Subject: Correspondence received regarding Item #4 – 1075 Pomeroy Avenue Four Units
Development Project

Re: 1075 Pomeroy Avenue, proposed development

I have the following comments and requests regarding the proposed rezoning and development for the 1075 Pomeroy Avenue Property:

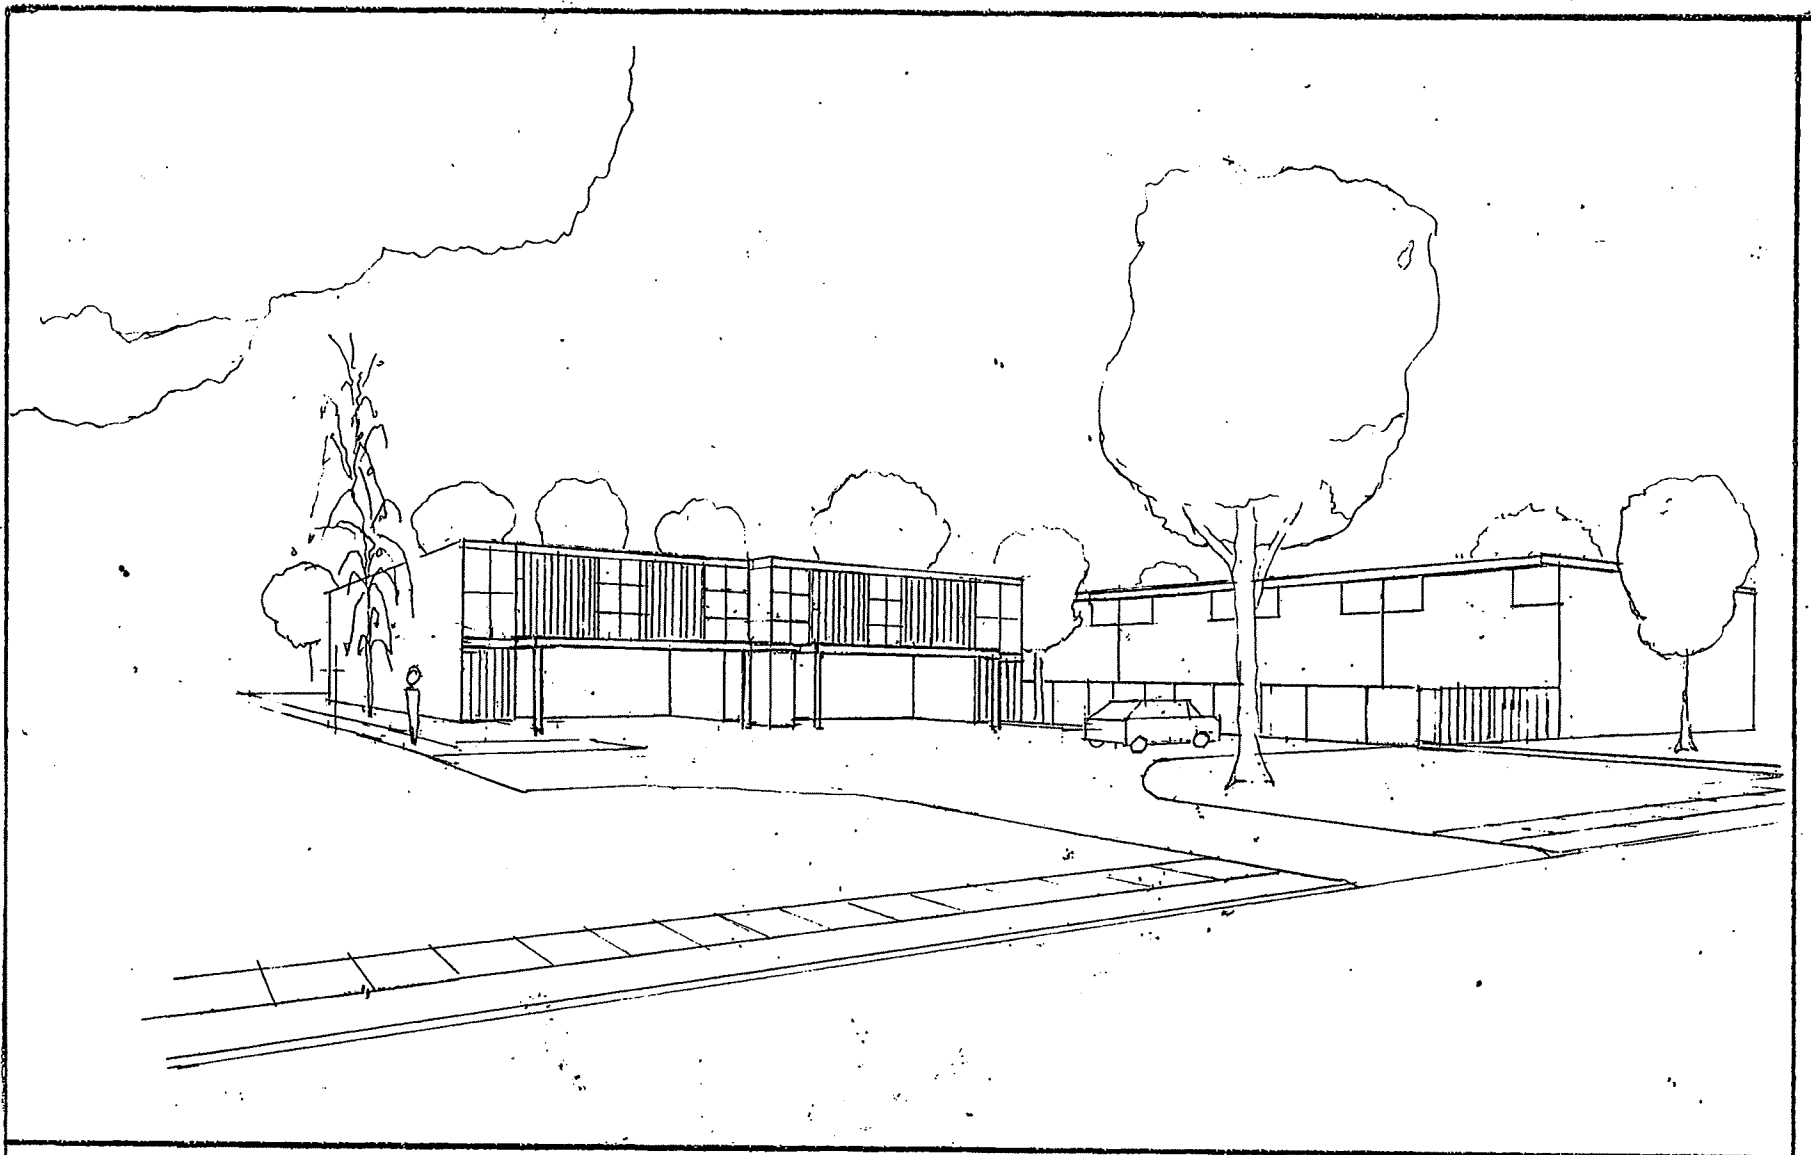
1. Please deny the rezoning request and proposed development at this time. One hundred and seventy-eight (178) of my neighbors and I signed a petition saying the proposal is not compatible. Please see the attached photo, labeled "site photo", of a model I constructed to scale of the developer's proposal and notice the lack of appropriate setbacks along the sides of the property in relation to the surrounding Pomeroy Green buildings..
2. Please grant the Historical and Landmarks Commission's recommendations.

Figure 2.7 - Second-story windows on House A are raised at least five feet above the finished floor, reducing privacy impacts.

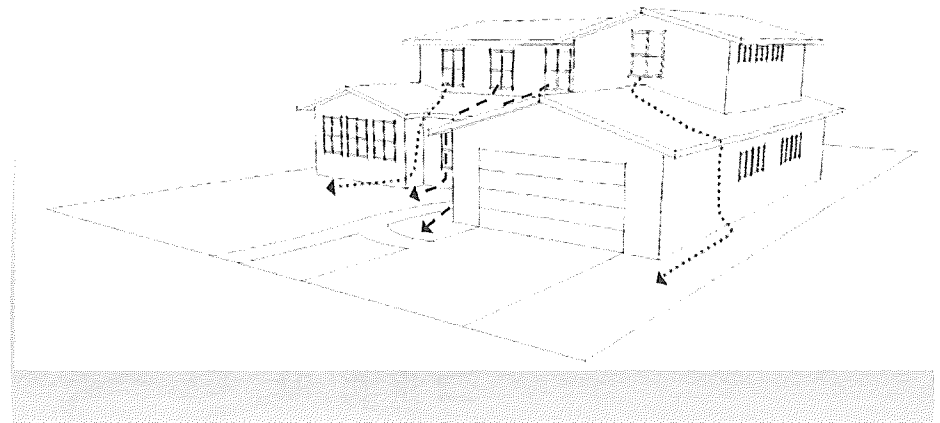
Project provides large 2nd floor windows A1 & B1 that are directly opposite 2nd floor windows in the adjacent Pomeroy Green building Q
